RE: Hydrologic Design Manual

PART 6

Appendix	Material
6-A	List of conference attendees
6-B	Conference Questionnaires
6-C	Mr. Gohmert's (SCS) Letter FCD Response Dr. Sabol's Response
6-D	Dr. May's (ASU) Letter FCD Response Dr. Sabol's Response
6-E	Mr. Creighton's (ADWR) Memo FCD Response Dr. Sabol's Response
6-F	Mr. Ramirez' (Mesa) Letter FCD Response
6-G	Mr. Bond's (Tempe) Letter FCD Response
6-H	Mr. Brunner (HEC) Letter FCD Response
6-I	Mr. Duren's (JMM) Letter FCD Response Dr. Sabol's Response
6-J	Mr. Miller's (JRJ) Letter FCD Response Dr. Sabol's Response
6-K	Mr. Kao's (AGK) Letter FCD Response

Figure 4.4
Green and Ampt Loss Rate
Wetting Front Suction in Inches (cm)
PSIF

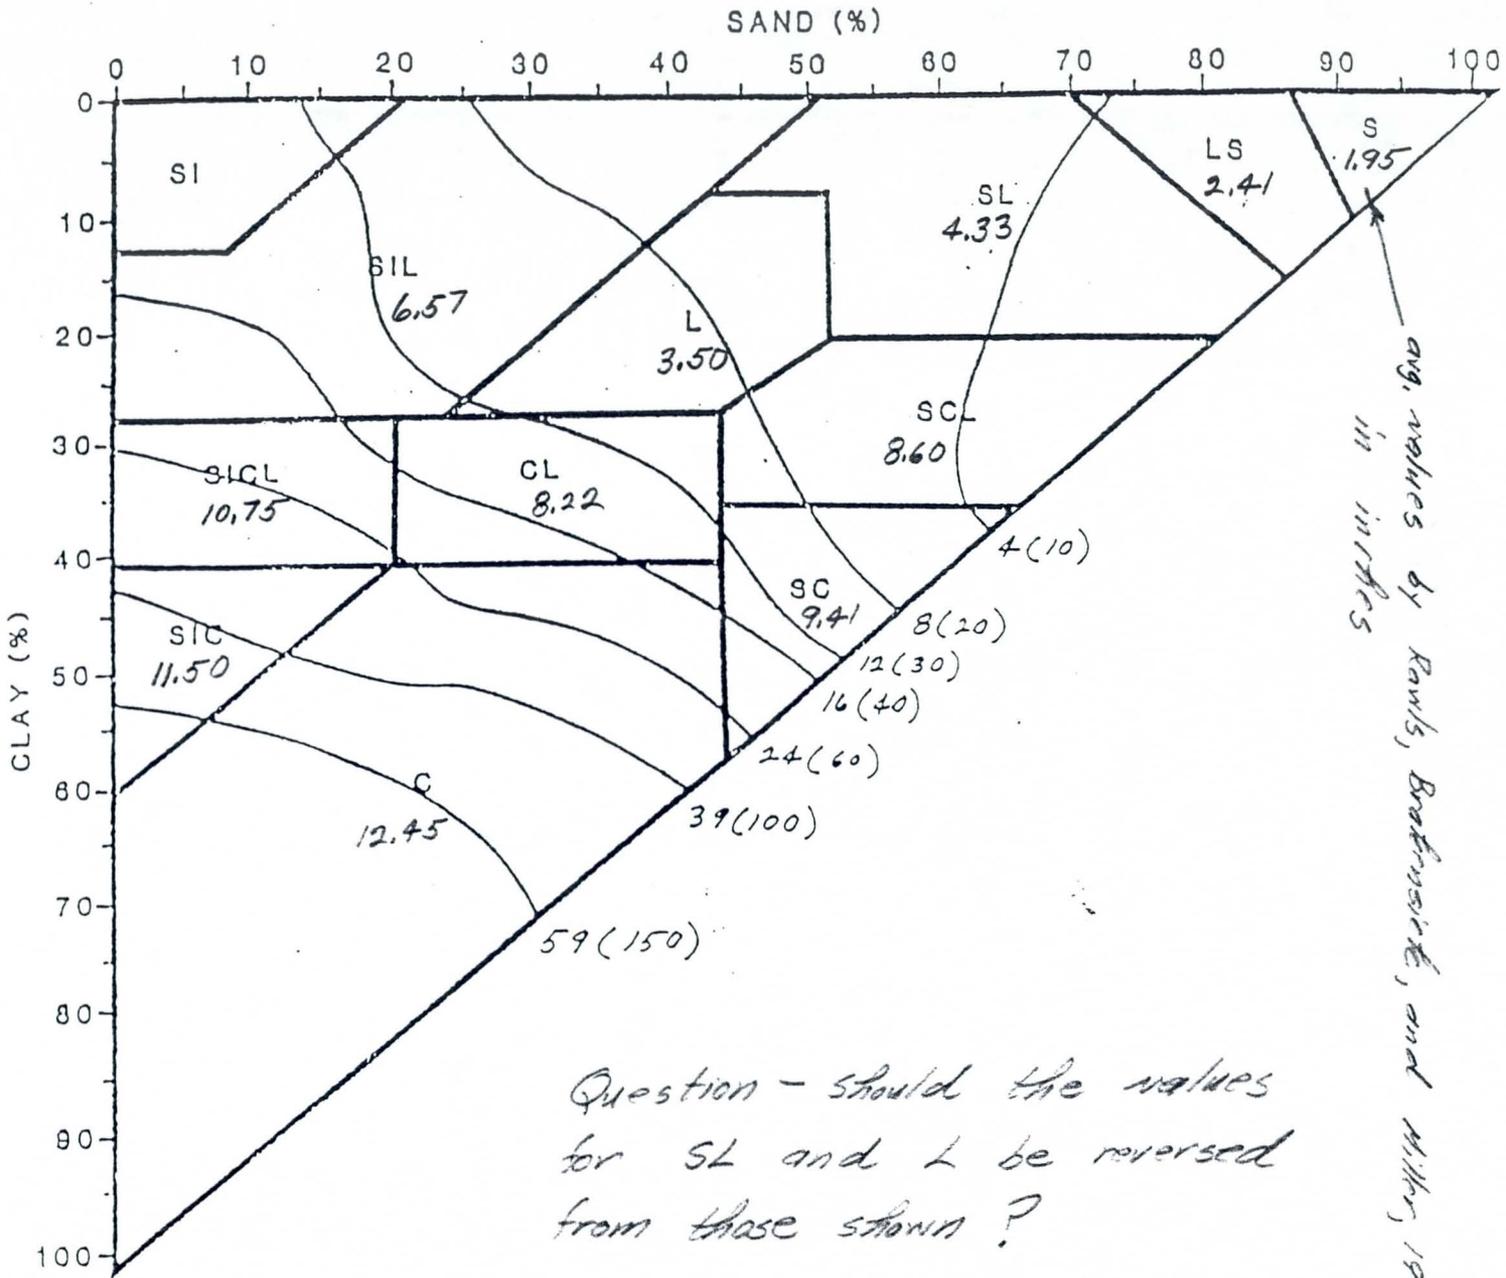
11.12 The source and basis for modifications for Figures 4.3, 4.4, 4.5, 4.6, 4.7, 4.8 and 4.9 should be more clearly identified and discussed. The values obtainable from figures 4.3 and 4.4 from centroids of soil classes most often do not appear close to the Table 4.2 parameter values. The relation to the spread of values may be relatable to the standard deviation range.
